# UNITED STATES PATENT AND TRADEMARK OFFICE

APPLICATION NO.	FILING DATE	FIRST NAMED INVENTOR	ATTORNEY DOCKET NO.	CONFIRMATION NO.
10/757,629	01/14/2004	Mark James Kline	8194C	4664

<b>Office Action Summary</b>	Application No. 10/757,629	Applicant(s) KLINE ET AL.	
	Examiner Laura C. Hill	Art Unit 3761

## **DETAILED ACTION**

**FIG. 1**

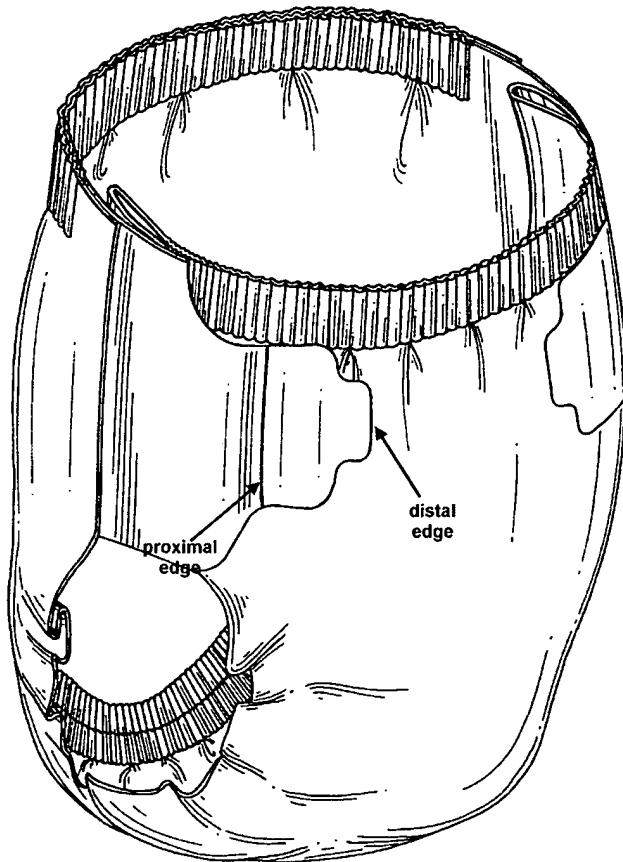
distal to proximal edge of the first fastening system. **Vukos** discloses disposable absorbent article to be worn about a user with a Y dimension increasing from a distal to proximal edge (figure 1).

One would be motivated to modify the fastening system of Schmidt with the increasing Y-dimension of Vukos since doing so would provide an easier mechanism to grip and open the tab and since both references disclose wearing articles with fastening systems. Therefore, it would be obvious to one of ordinary skill in the art at the time the invention was made to modify the fastening system, thus providing a fastening system with an increasing Y-dimension from the distal to proximal edge.

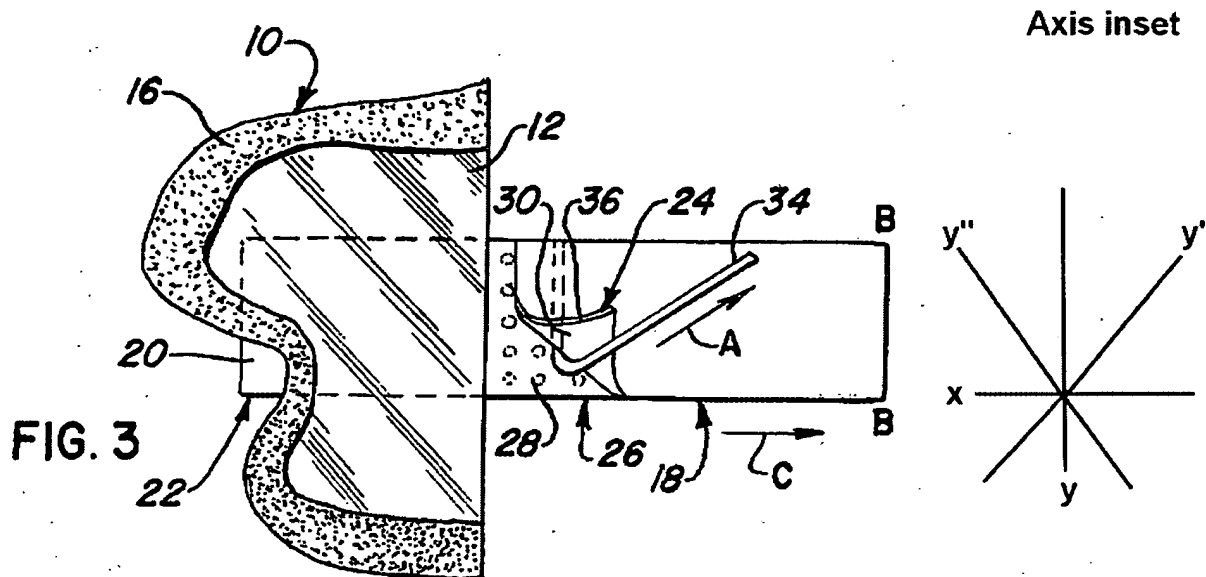
Regarding claim 4 Vukos further discloses the proximal/lower edge being longer than the distal/upper edge (figure 1).

Regarding claim 5 Schmidt/Vukos further disclose protective cover strip/second facing fastening element 30 having a portion of the lower edge being unjoined or at least partially detached from the underlying structure (figure 3).
